MAJOR ALTERATIONS + ADDITIONS TO
THE STEVENSON LIBRARY (SSD 8922)

S4.55 Modification Application

S4.55-2 MODIFICATION APPLICATION

1 Proposed Section AA
Scale: 1:200

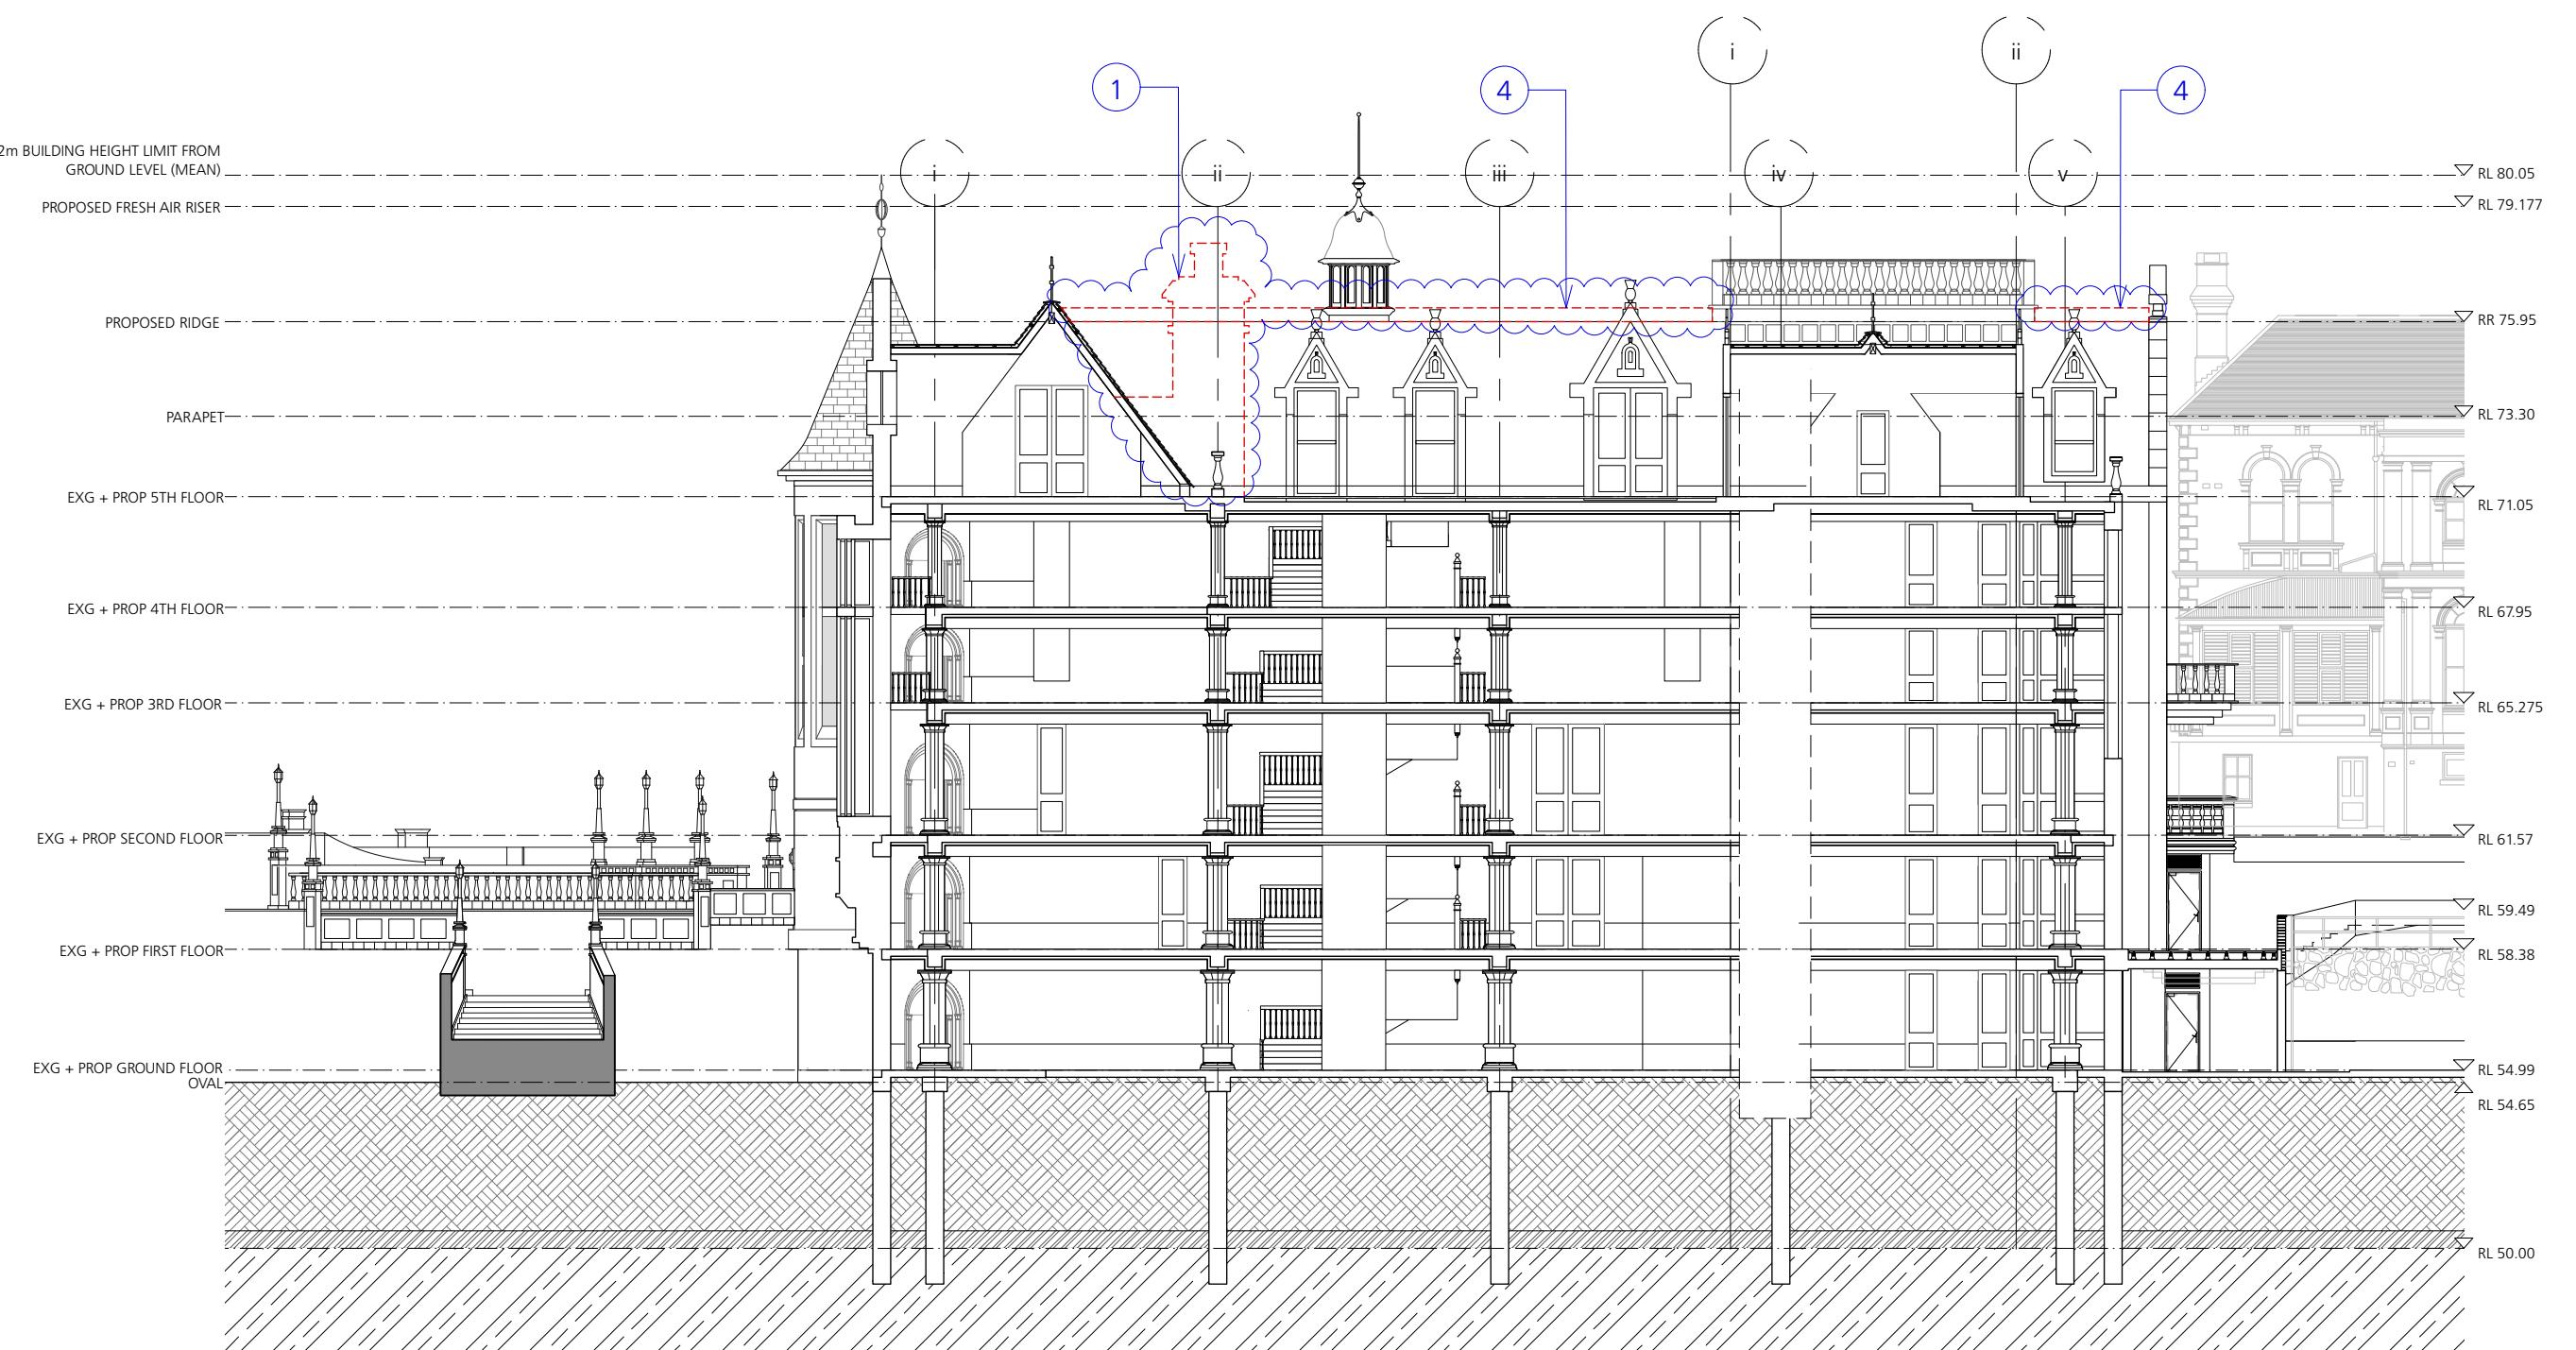
1. CHIMNEY DELETED.
2. TWO FRESH AIR LOUVRES ADDED.
3. REDUCED PROFILE OF TWO DORMERS TO SOUTHERN FACADE
4. RIDGE CREST DELETED.

Proposed Section BB
Scale: 1:200

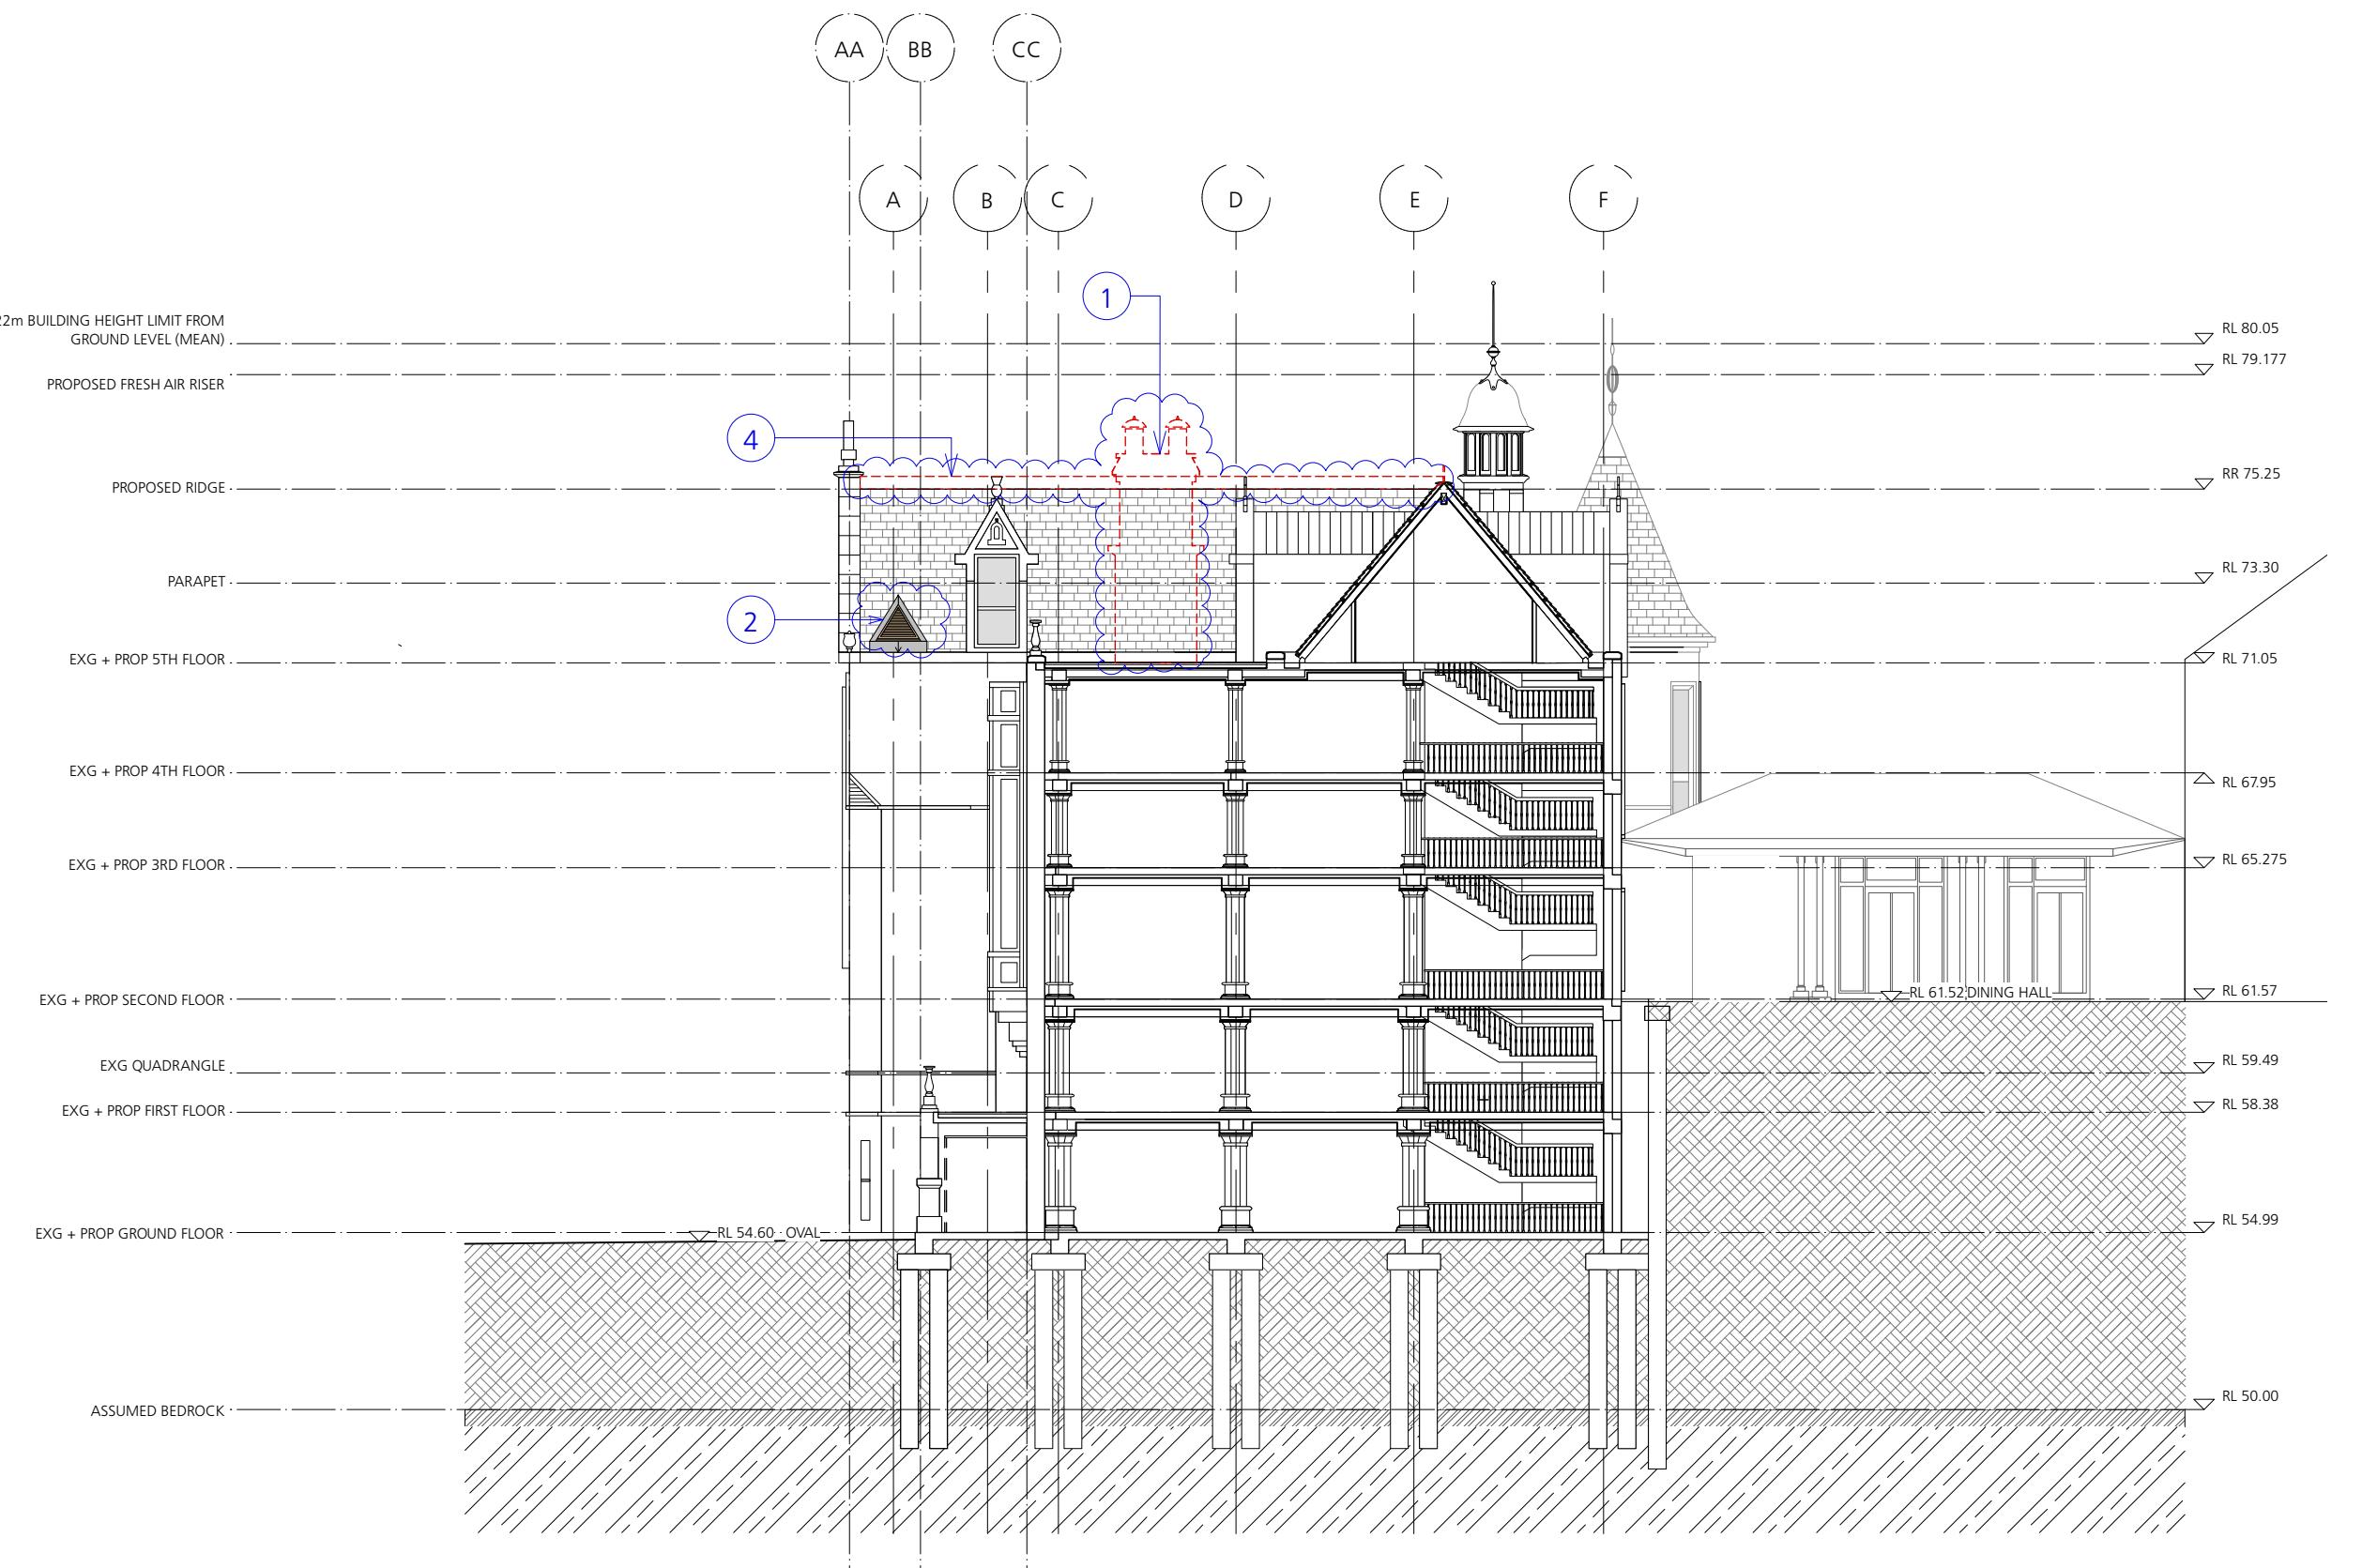
1. CHIMNEY DELETED.
2. TWO FRESH AIR LOUVRES ADDED.
3. REDUCED PROFILE OF TWO DORMERS TO SOUTHERN FAÇADE
4. RIDGE CREST DELETED.

Proposed Oval / East Elevation Context
1:1000

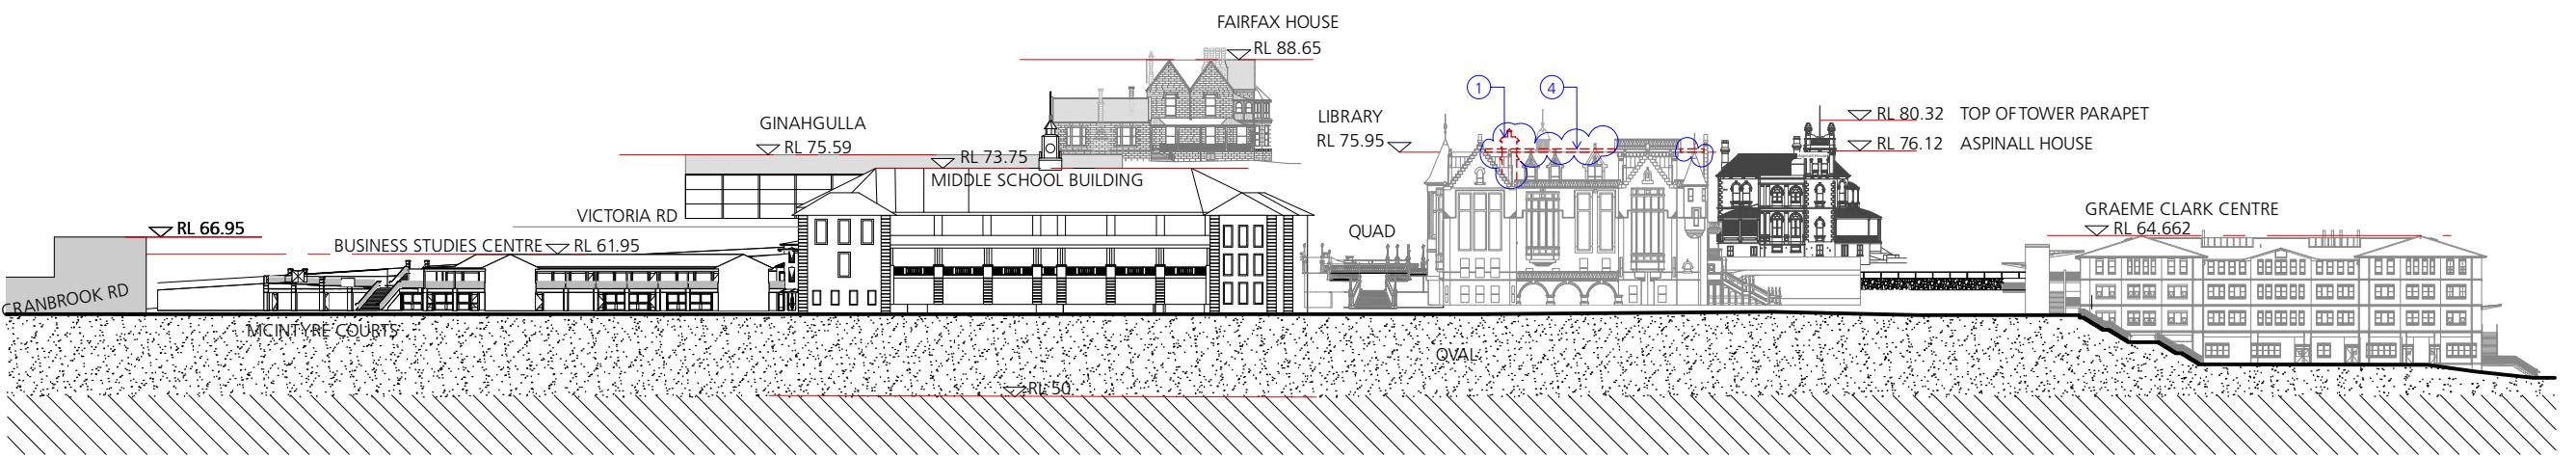
1. CHIMNEY DELETED.
2. TWO FRESH AIR LOUVRES ADDED.
3. REDUCED PROFILE OF TWO DORMERS TO SOUTHERN FACADE
4. RIDGE CREST DELETED.
